PRODUCT CHANGE NOTIFICATION

SURGE PROTECTIVE DEVICES

Select Bourns® Surge Protective Devices

Changes to Inner Packaging

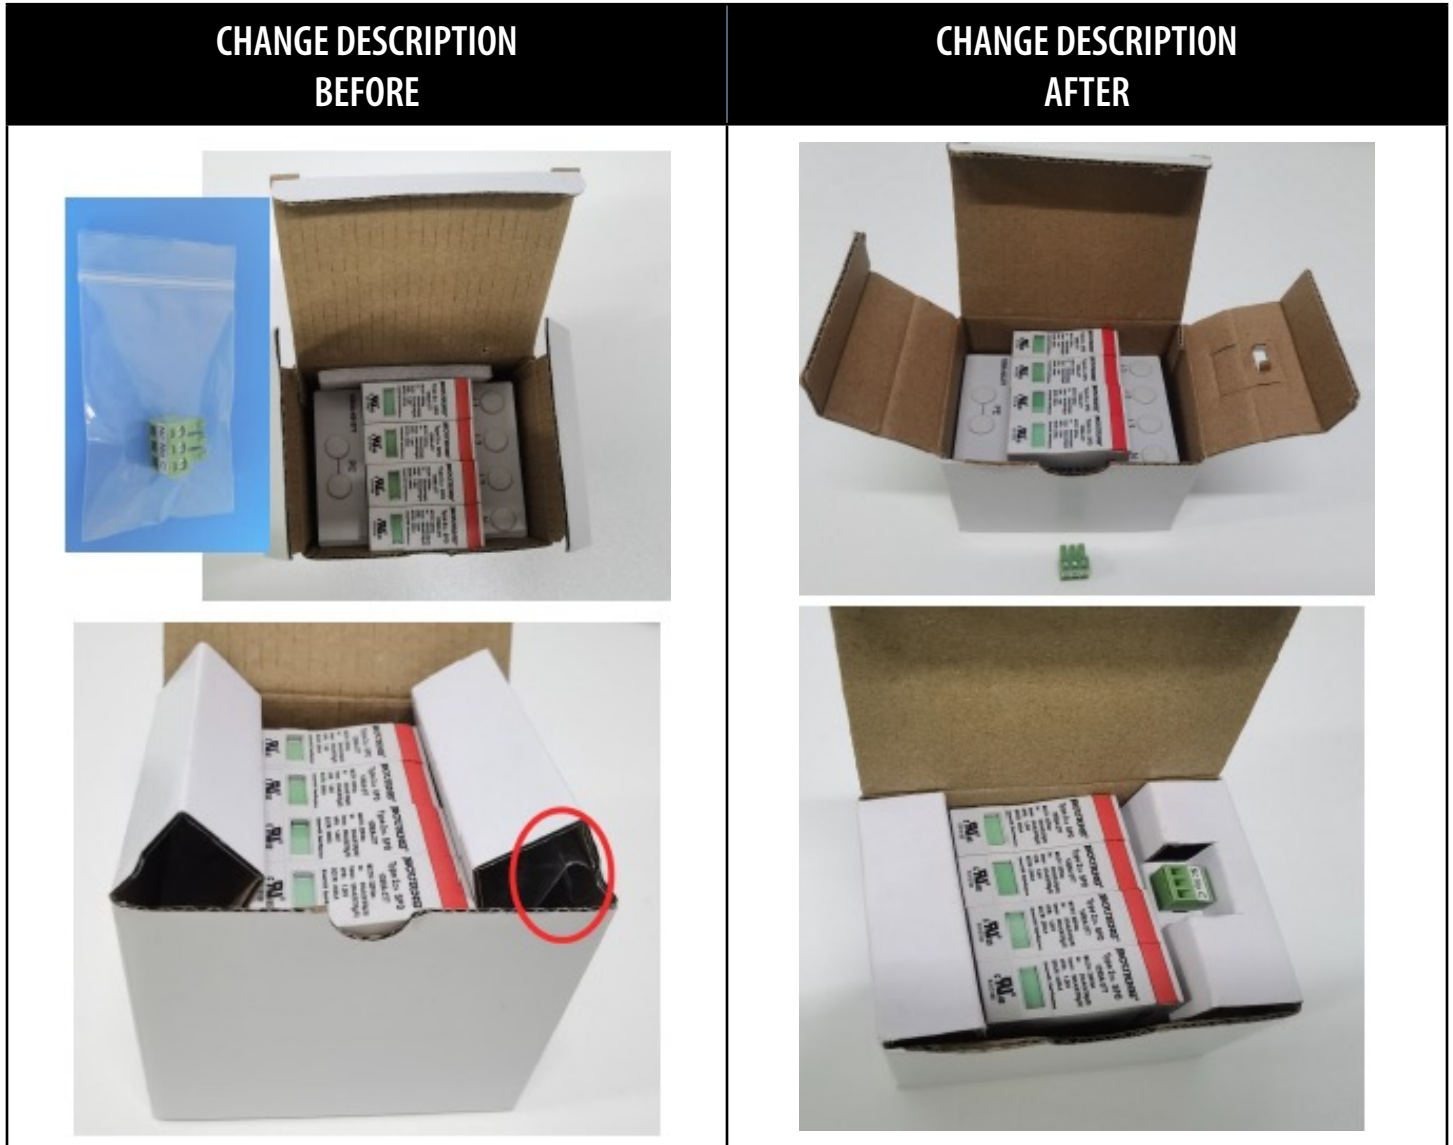
To meet the EU Plastic Tax Regulation, we will eliminate the plastic bag which is used to hold the remote signal terminal of the SPD. Consequently, we will change the inner packaging structure with a notch to fit and protect the remote signal terminal. The packaging size will be changed accordingly.

The change to the inner packaging will have no effect on the form, fit, function, quality, or reliability of the affected part numbers as this is a packaging change only. The product specifications will not change.
